UNITED STATES PATENT AND TRADEMARK OFFICE

APPLICATION NO.	FILING DATE	FIRST NAMED INVENTOR	ATTORNEY DOCKET NO.	CONFIRMATION NO.
10/669,479	09/24/2003	Steven G. Goebel	GP-303584	3973

Office Action Summary

DETAILED ACTION

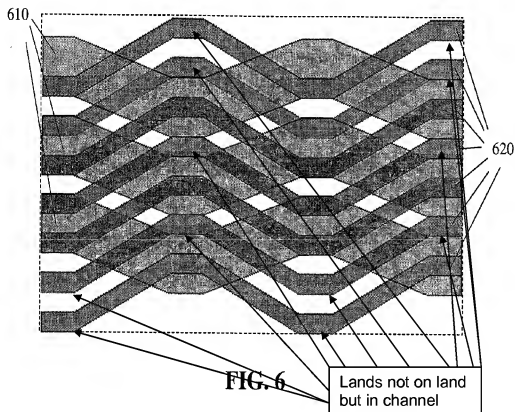
the two distinct embodiments disclosed by the figures. As can clearly be seen in figure 6, which is the only figure that shows the embodiment of alternating angles, there are in fact lands 620 that do not align with lands 610 as illustrated below:

As seen above there are at least 12 lands labeled as 620 that overlap in a channel region (channel region is defined by the white areas) not to mention all of the diagonal areas that overlap in a channel region. Therefore the recitation that the first lands do not align with the second channels is new matter.
